Project name:
Palo Alto Rail Program Management

Date:
December 17, 2019 (Update from 12/5 version)

Memo

Subject: "New Ideas" from XCAP Technical Working Group

Price - Typical Section for Churchill Concept

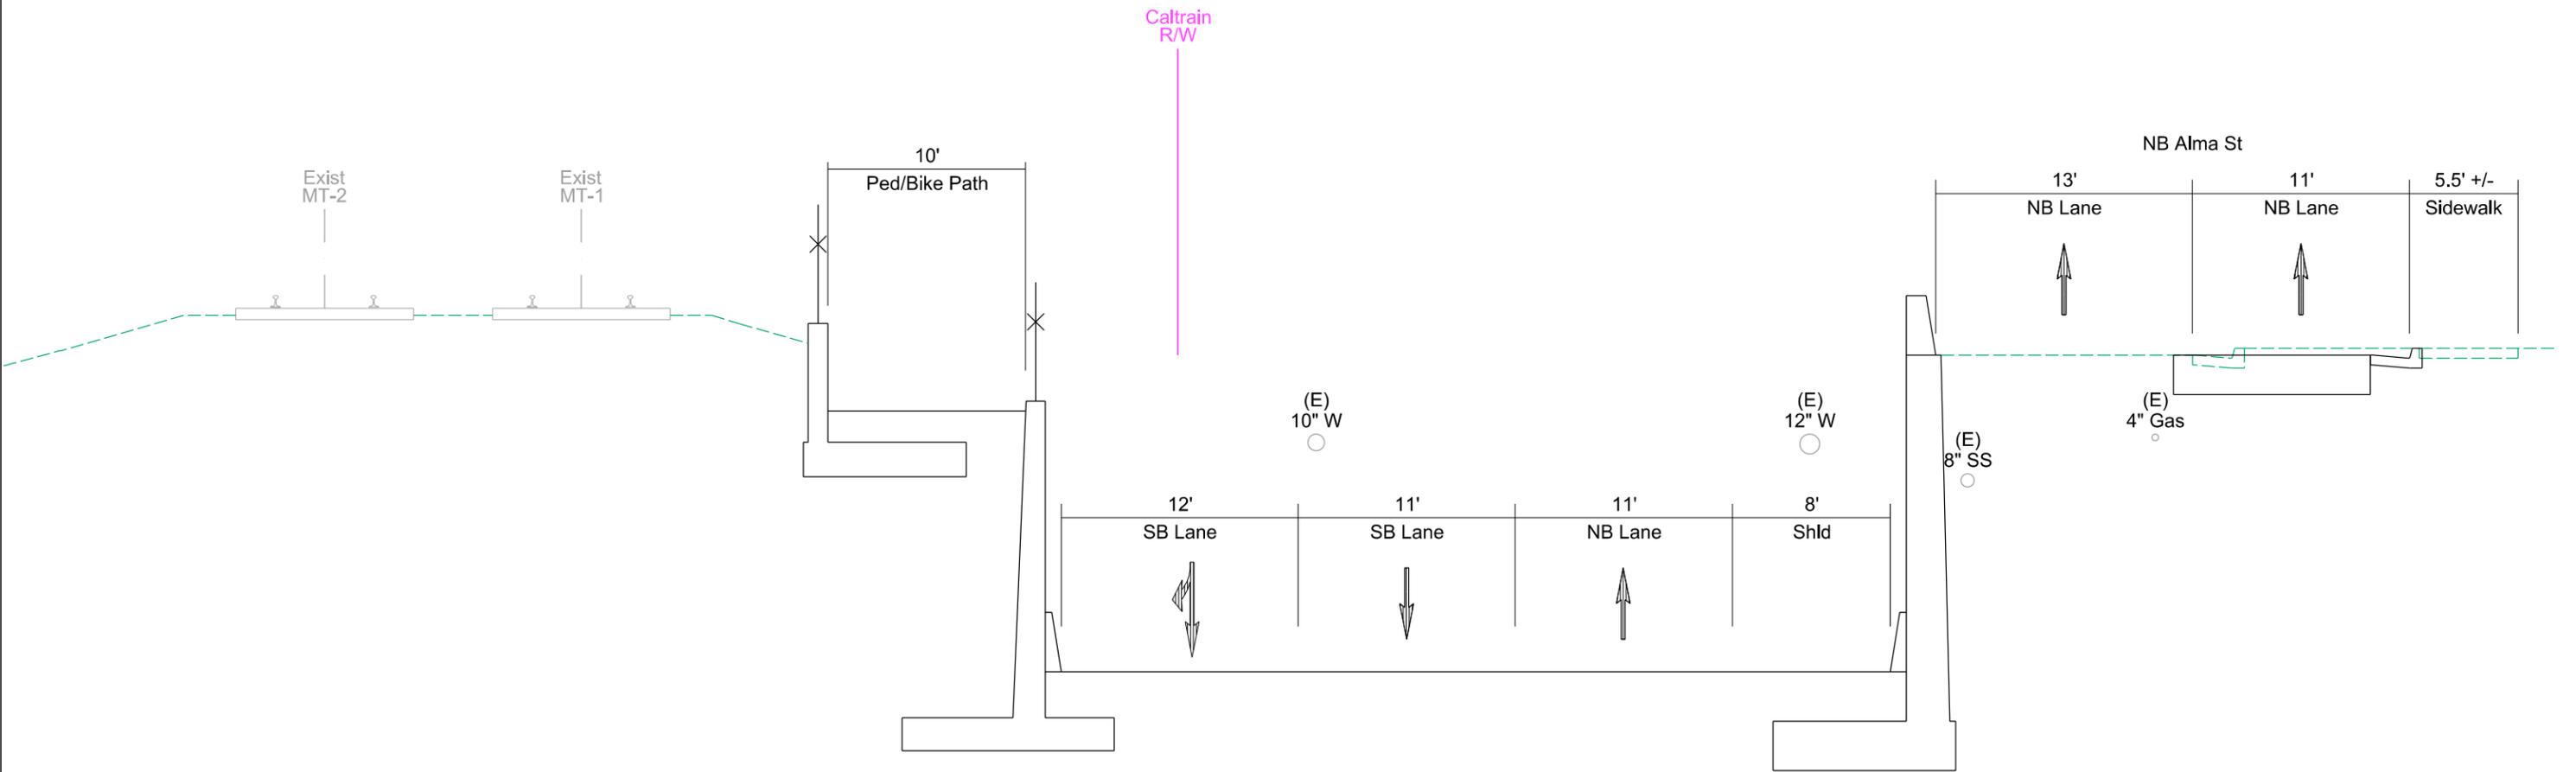
- The retaining walls on Alma will be tall (~20 feet Max) and will have a tunnel-effect. Providing left and right shoulders would be ideal, especially 8 to 10-foot right shoulders for disabled vehicles. **To provide an 8-foot right shoulder on NB Alma St (connecting to Churchill Ave in the underpass), the landscaping strip on the east side of Alma St will have to be removed. This will reduce the setback distance from the curb line for many homes fronting Alma by approximately 9.5 feet.**

- Temporary Construction Easements (TCEs) **will be required.**
- **Full acquisitions likely not required, but partial/sliver residential takes potentially needed along Alma St and potentially a home on the east side of Mariposa Ave.**
- **Curb setback distances must be reduced for homes along Alma St, as noted above.**
- **Potential minor relocation of the ped/bike trail on the north side of Churchill (between Castilleja Ave and the railroad).**
- **The far-right lane on SB Alma St will encroach inside Caltrain’s R/W. This will have to be reviewed/approved by Caltrain.**

Price - Churchill Underpass Layout

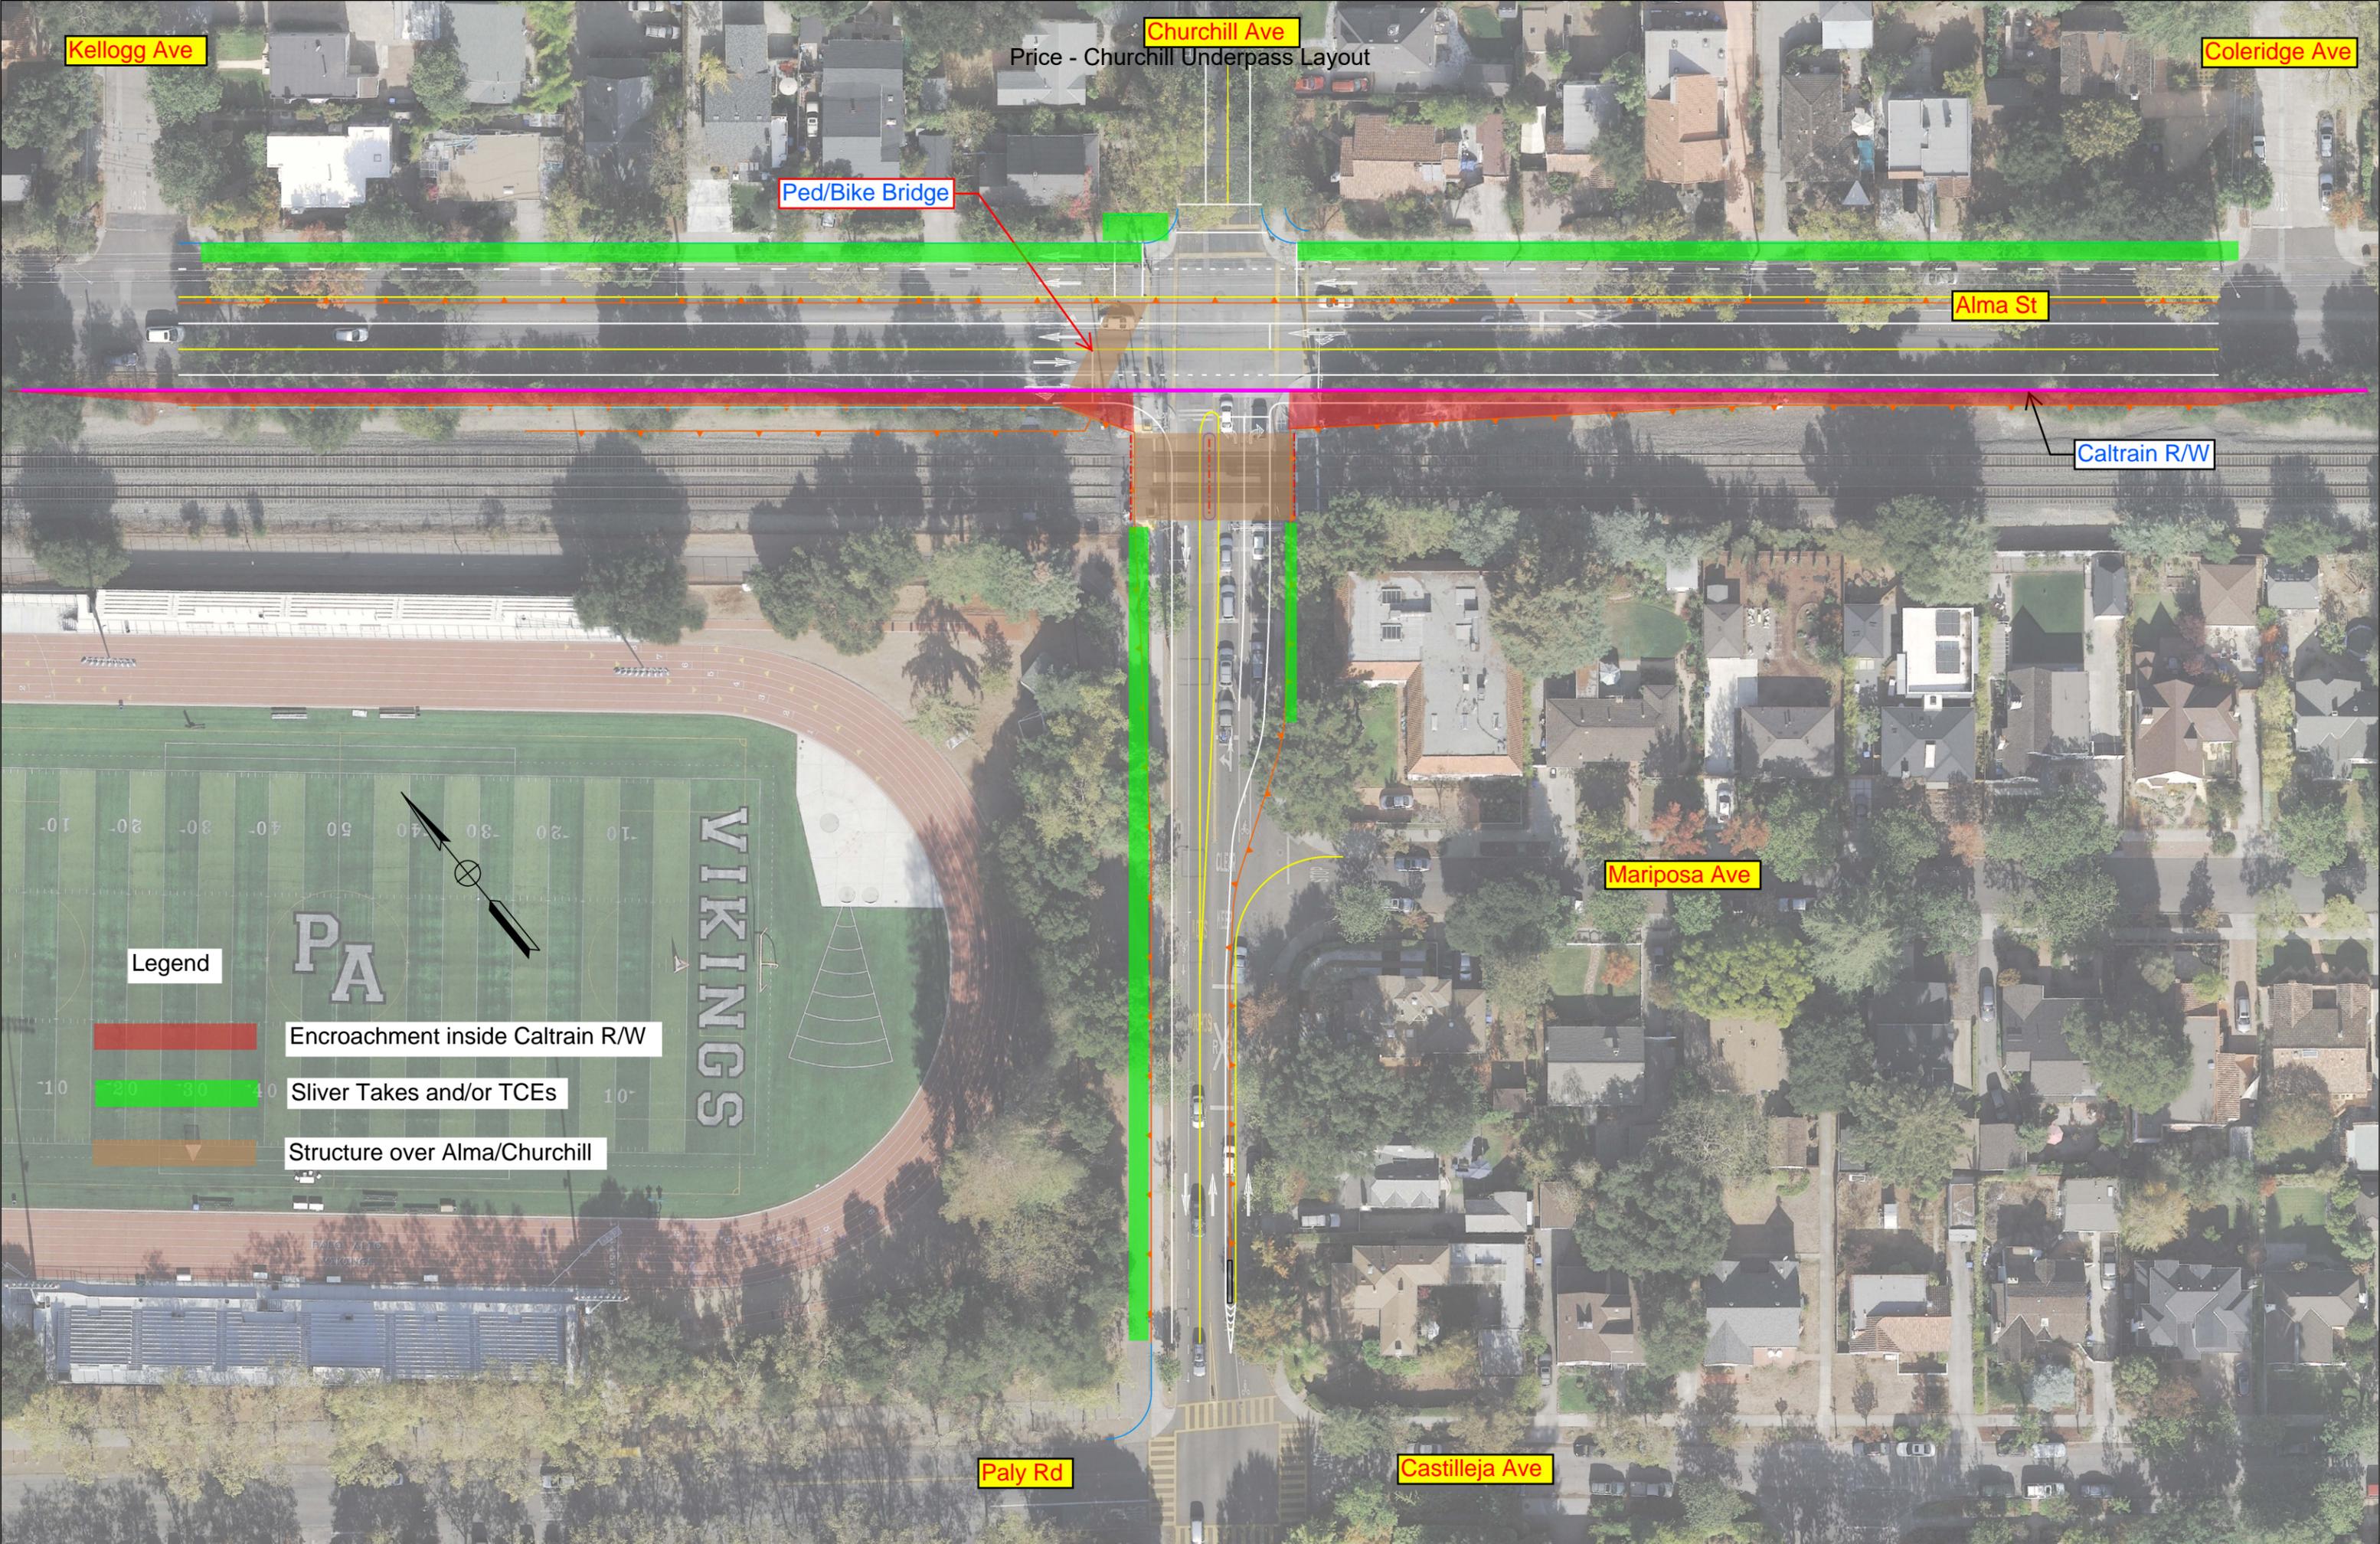
- The bridge geometry and lane configurations need to be hashed out. We’ll need two through lanes on NB Alma.
- **The sight distance at the T-intersection of Churchill and Alma will be less-than-standard for vehicles making rights/lefts onto Alma from EB Churchill. This is mainly due to very little space available for a right shoulder on SB Alma.**

- This concept will create circuitous routes for some and introduce more traffic on residential streets.
- Several traffic movements are eliminated... likely to cause driver confusion for those not familiar with the configuration:
 - a. Traffic from WB Churchill must turn right onto NB Alma
 - b. No thru-movement allowed on Churchill
 - c. Traffic from SB Alma cannot make a left onto EB Churchill
 - d. Traffic from NB Mariposa cannot access Churchill (vehicles would have to turn around). Residents on Mariposa (south of Churchill and north of Miramonte) would be forced to travel south, generating more traffic on other Southgate neighborhood streets (Castilleja Ave and Miramonte Ave).

- e. One private driveway on Churchill (between Castilleja and Mariposa) will front a one-way “frontage” road (traveling north), which will force them to travel north and make a right onto Mariposa to exit the Southgate neighborhood.
- f. Left turns not allowed from WB Churchill onto Mariposa (same condition as today).
- g. The left turn movements to/from Kellogg Ave and Coleridge Ave will have to be prohibited because drivers trying to make a left turn onto Alma will not have adequate sight distance to approaching vehicles traveling on NB and SB Alma St, respectively. A concrete barrier will likely be placed at these locations to prohibit the left-turn movements at each intersection.

Typical Section
Charleston Rd (East of Alma St)

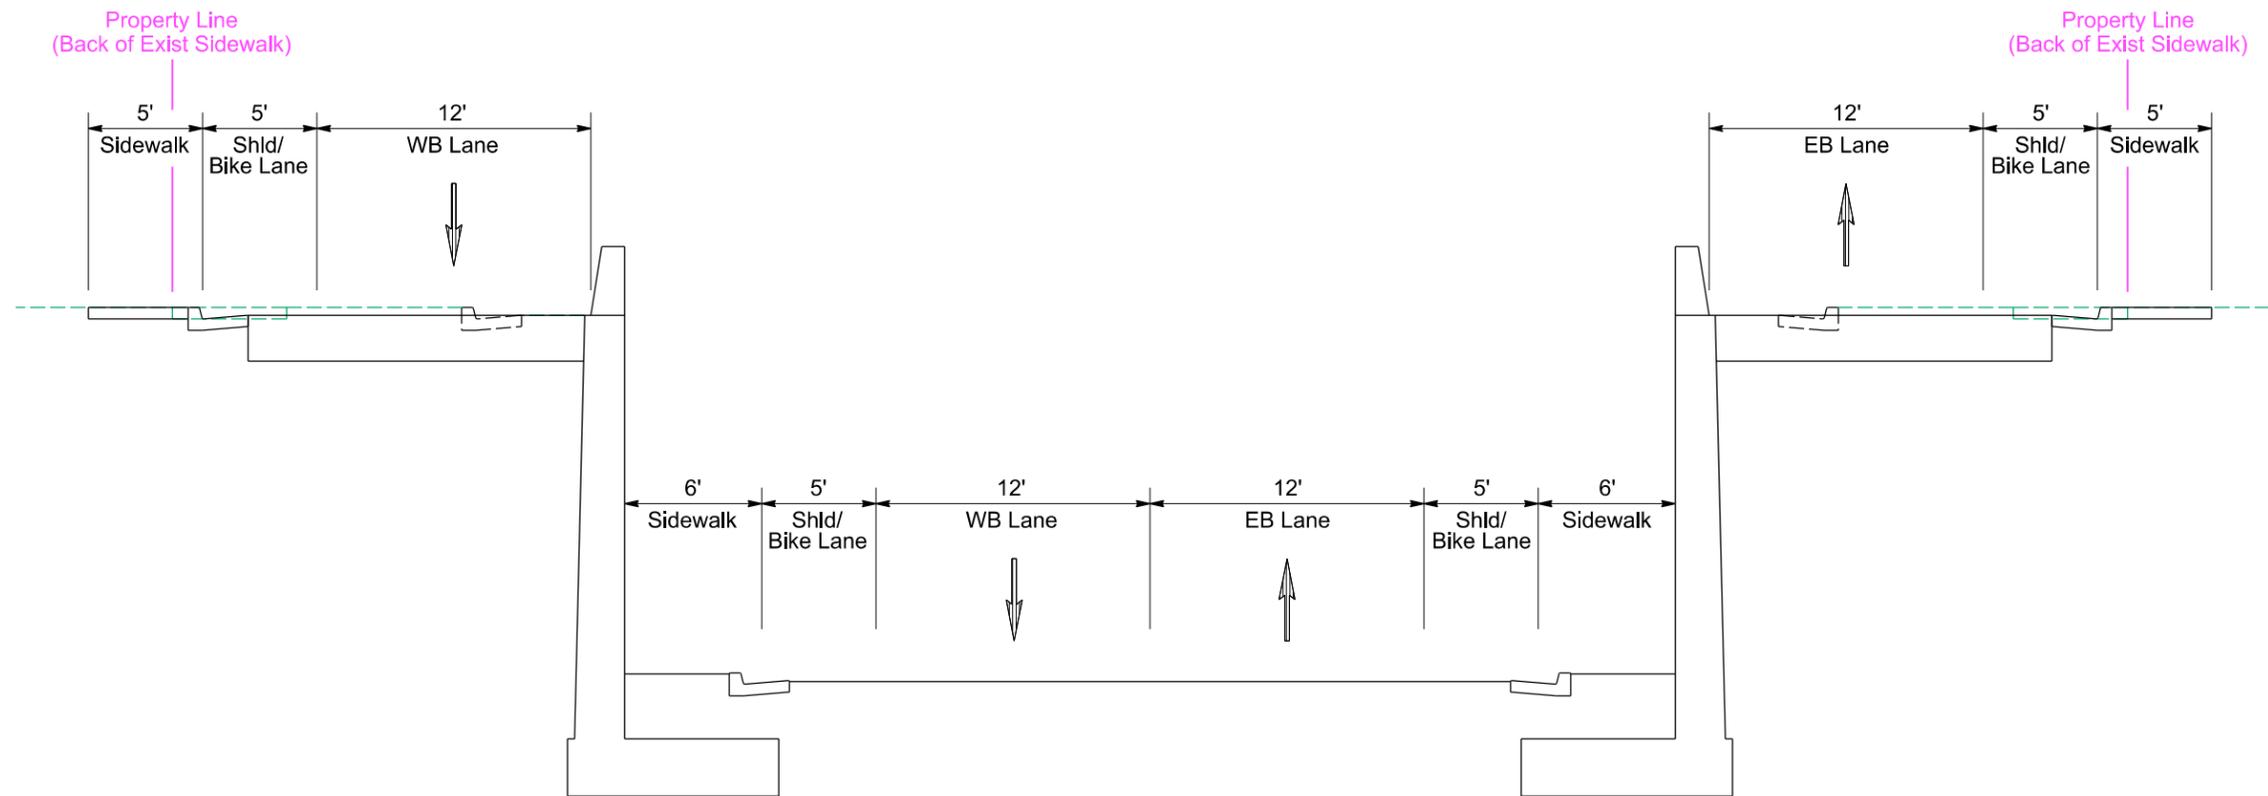
- Slide 8 does not show standard merge distances, so the footprint (along M/C) would likely be much larger than presented on this slide.
- The existing width of Charleston on the east side of the tracks (from back of sidewalk to back of sidewalk) is approximately 85 feet. To obtain an adequate cross section of the frontage roads and underpass, we need approximately 95 feet of width, which will require a sliver acquisitions on each side of the road (see x-section). The curb setback distance for the homes on the south side Charleston would be reduced by ~ 16 feet.
